REMARKS

The present communication responds to the Office Action of March 21, 2006, in which the Examiner objected to the drawings and rejected claims 1-10.

Fig 1

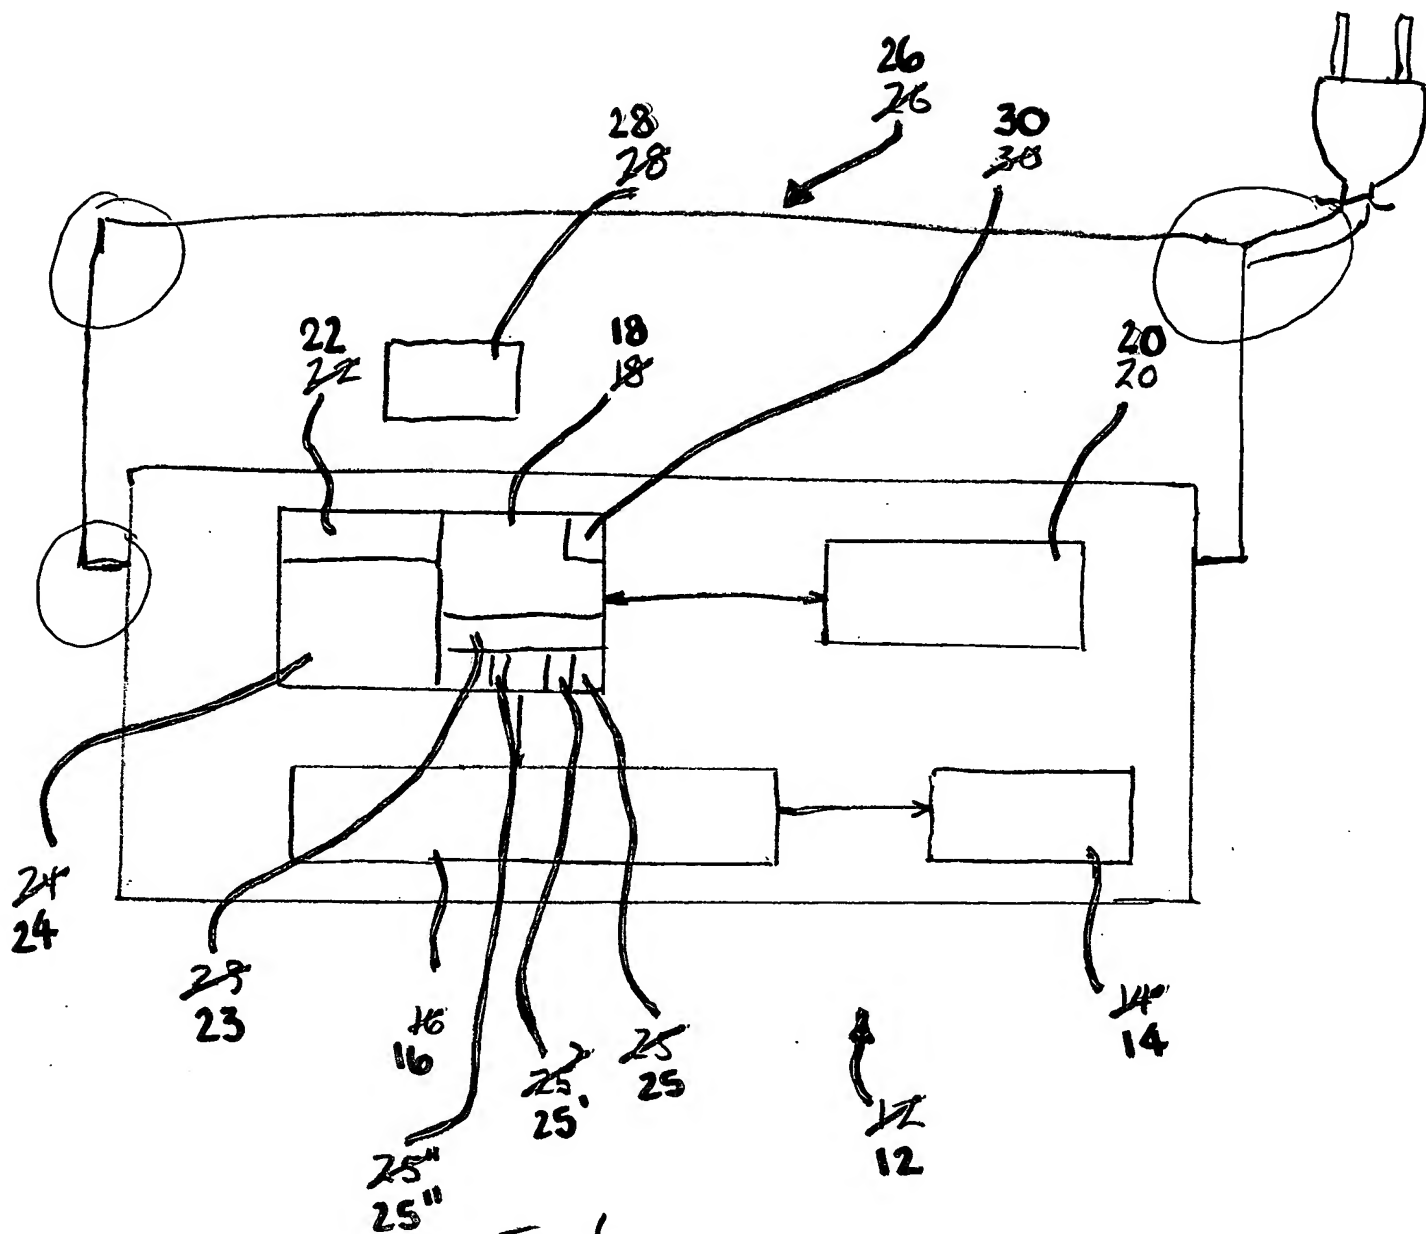
In the Office Action, the Examiner objected to the drawings because “the lines are not uniformly thick, well defined and the reference numbers are not plain and legible.” The applicants are herewith submitting a replacement drawing sheet with redrawn lines and clearer reference numbers.

The attached drawing sheets, including a replacement sheet and an annotated sheet, show changes in Fig. 1. The replacement sheet replaces the original sheet carrying Figure 1. In Figure 1, lines have been redrawn and the reference numbers have been clarified.
